# UNITED STATES PATENT AND TRADEMARK OFFICE

| APPLICATION NO.  | FILING DATE | FIRST NAMED INVENTOR | ATTORNEY DOCKET NO.      | CONFIRMATION NO. |
|--|-------------|----------------------|--------------------------|------------------|
| 10/774,799   | 02/09/2004  | Perry Scott Lorenz   | 08211/0200372-US0/P05790 | 9070             |

| <b>Office Action Summary</b> | <b>Application No.</b> | <b>Applicant(s)</b> |

## **DETAILED ACTION**

FIG. 1

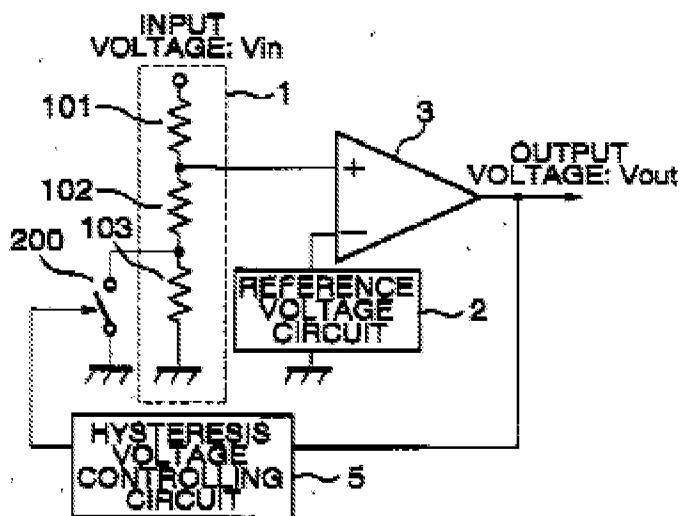
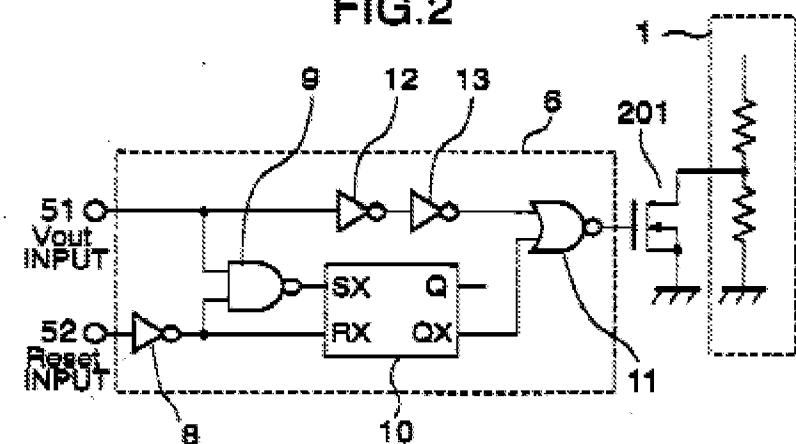
With respect to claim 1, figure 1 and 2 of Matsumura (US 6163183) discloses a circuit for temperature sensing, comprising: a comparator circuit (3 of fig 1) that is arranged to provide a trigger signal by comparing a reference signal (2) to a temperature sensor signal (1); a gate circuit (201 of fig 2 or 200 of fig 1) that is arranged to provide an output signal ( $V_{out}$ ) by gating a gate input signal ( $V_{in}$ ) subject to control

by a gate Control signal (from 5 fig 1 or from 6 fig 2), wherein the gate input signal is based at least in part on the trigger signal (51 fig 2), and wherein the gate control signal is based at least in part on a power-on-reset signal (52 of fig 2); and a hysteresis-and-output-sensor circuit (5 fig 1 or 6 fig 2) that is configured to control the reference signal in response to a sensed signal, wherein the sensed signal is based at least in part on the output signal (Vout), and wherein the hysteresis-and-output sensor circuit is arranged to disable a hysteresis at power up but fails to disclose a power-on-reset generator that is arranged to provide a power-on reset signal.

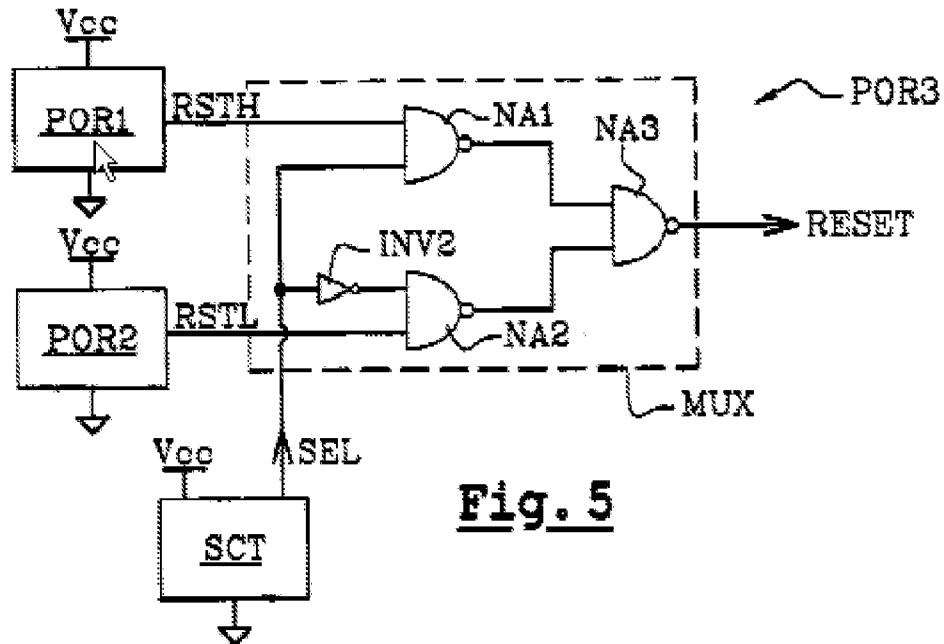
Figure 5 of La Rosa (US 6897689) discloses a POR circuit to generate a reset signal. It would have been obvious at the time the invention was made to a person having ordinary skill in the art to use the POR reset circuit of Rosa in the Voltage detecting

circuit of Matsumura for the purpose of incorporating a POR circuit into an integrated circuit that can receive different supply voltages.
